Sundry Notices and Reports on Wells

8. Well Name & Number
Jicarilla C #12
9. API Well No.

Attachment to Notice of
Intention to Abandon

Re: Permanent Abandonment

AFTER P & A

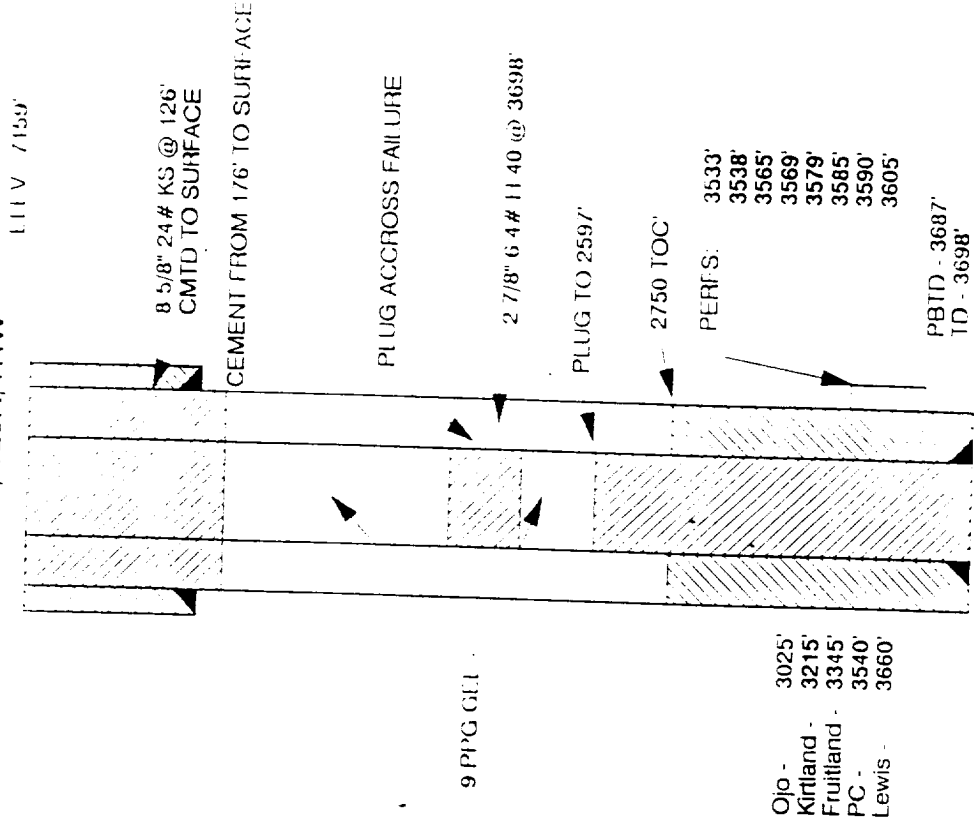
Add a plug from 1500-1400 inside outside the casing (2 7/8").
